From: [REDACTED]
Sent: 15 July 2026 21:08
To: Planning
Cc: Alice.Johnson; John Milne MP
Subject: DC/25/2057 Land North of Little Slaughterford, Chapel Road, Barns Green, West Sussex
Attachments: Southern Water Letter dated 26-03-2015.PDF; Southern Water Letter dated 09-04-2025 (Redacted).pdf

Objection: Application DC/25/2057 Land North of Little Slaughterford, Chapel Road, Barns Green, West Sussex – 68 Dwellings by Miller Homes

Sewage Treatment Capacity and Discharges into Parsons Brook

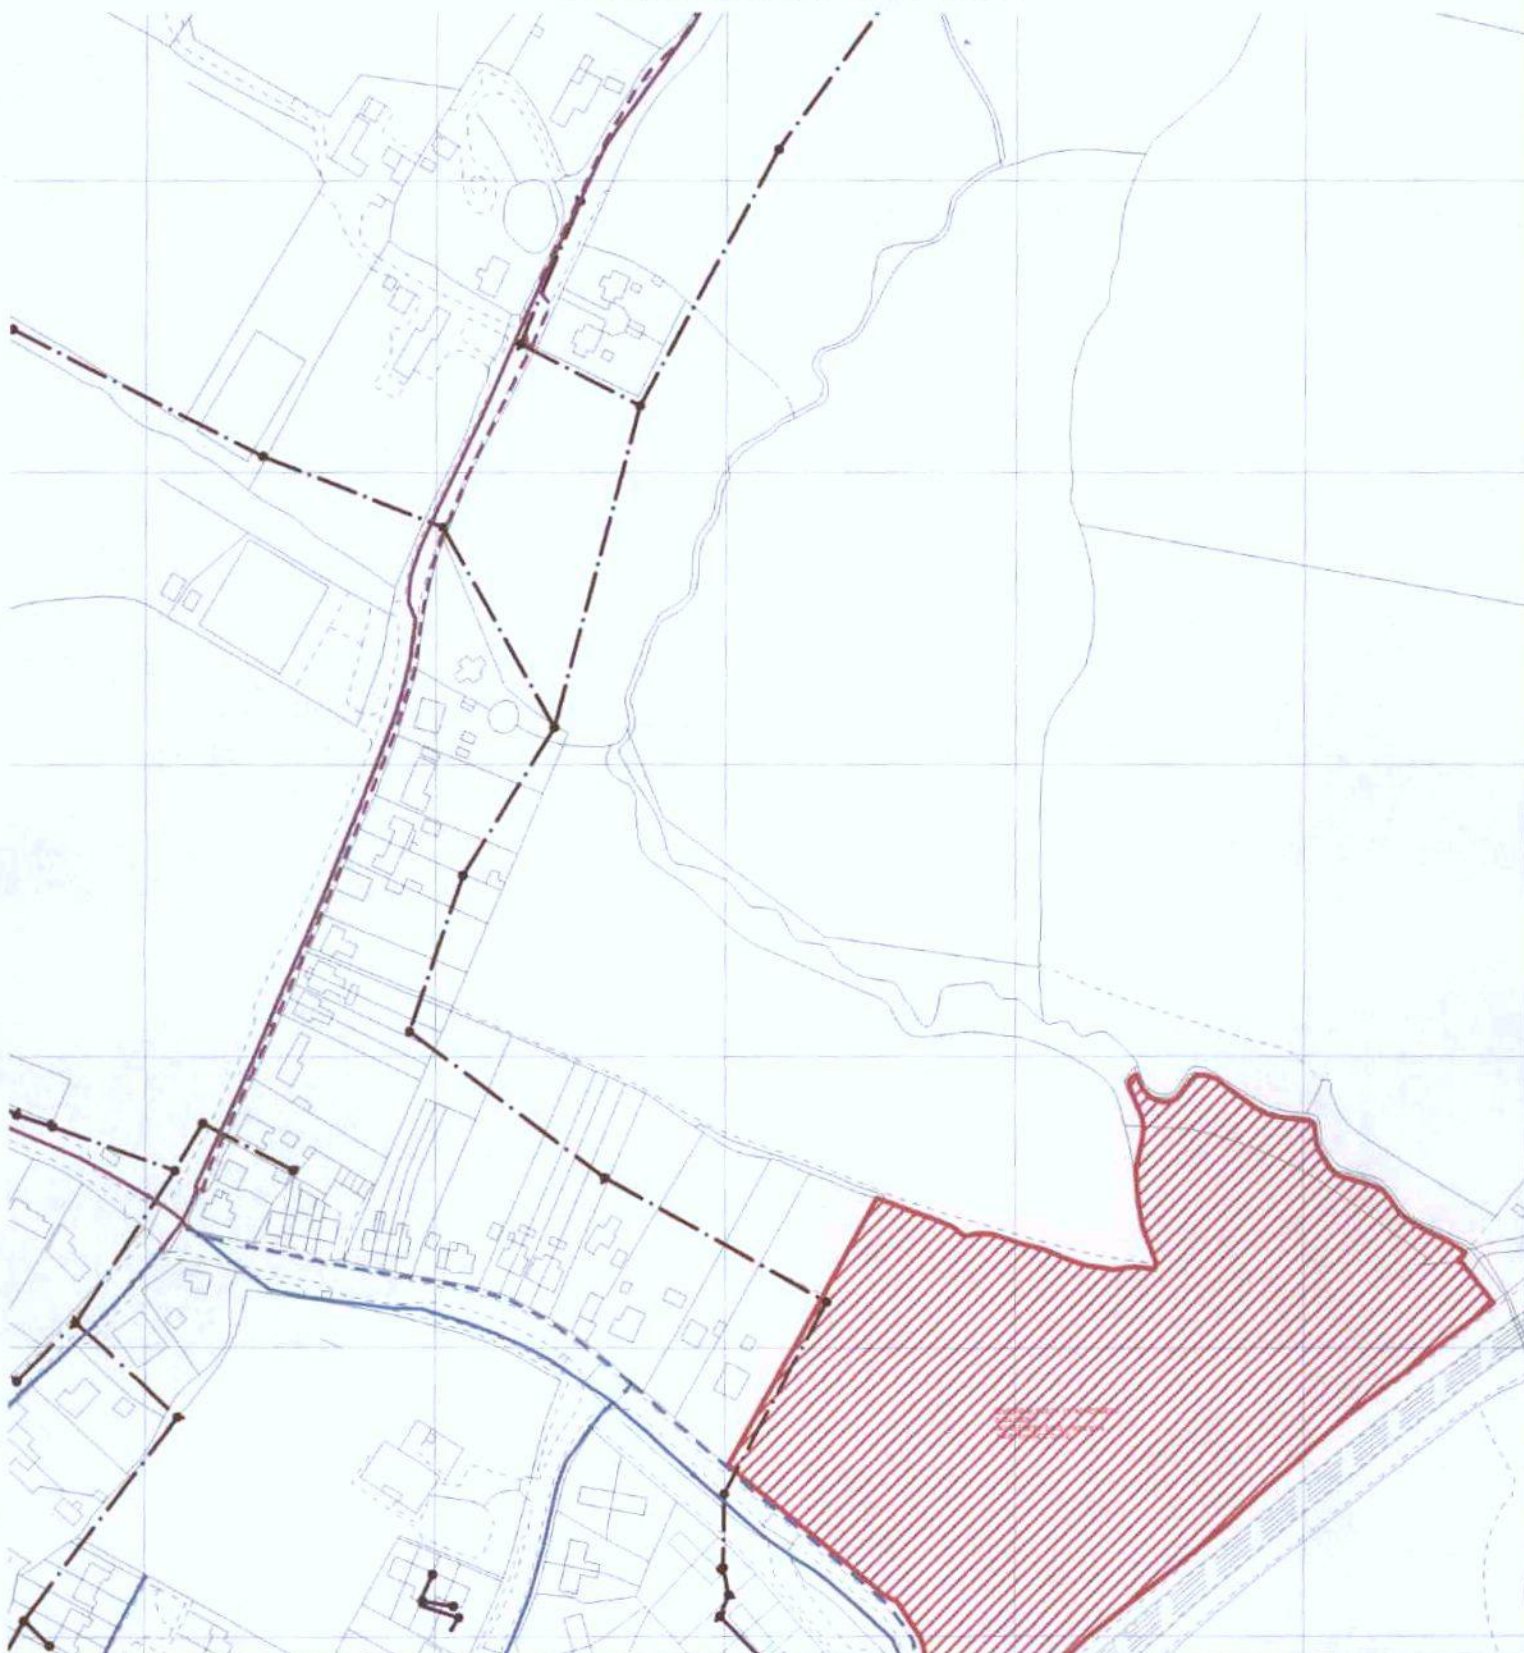
Please find attached a plan of the sewer records showing the approximate position of foul sewer crossing the site. The exact position of the public sewers must be determined on site by the applicant before the layout of the proposed development is finalised.

It might be possible to divert the foul sewer, so long as this would result in no unacceptable loss of hydraulic capacity, and the work was carried out at the developer's expense to the satisfaction of Southern Water under the relevant statutory provisions.

1. The 150 mm diameter sewer requires a clearance of 3 metres either side of the sewer to protect it from construction works and allow for future access for maintenance.
2. No development or new tree planting should be located within 3 metres either side of the centreline of the public sewer
3. No new soakaways should be located within 5 metres of a public sewer.
4. All other existing infrastructure should be protected during the course of construction works.
